Subject: FLOOR UNDER COVER FALLS OFF AFTER DRIVING ON SNOW AND ICE	Bulletin No.: 09-039/18
	Last Issued: 11/01/2018

2017-2018 CX-5

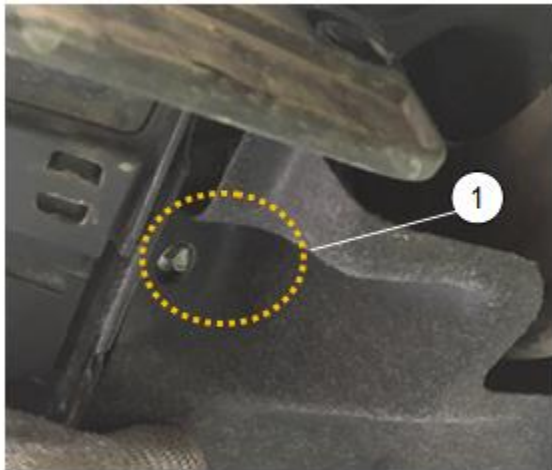
Some customers may notice the floor under cover No.2 falling off at the bolt (1) location after driving through snow and/or ice. This may be caused by snow and/or ice accumulation under cover No. 2 (as shown below).

This concern is caused because the bolt hole is too large for the bolt to hold the under cover when snow and/or ice accumulates under the body. To eliminate this concern, the bolt hole diameter has been reduced.
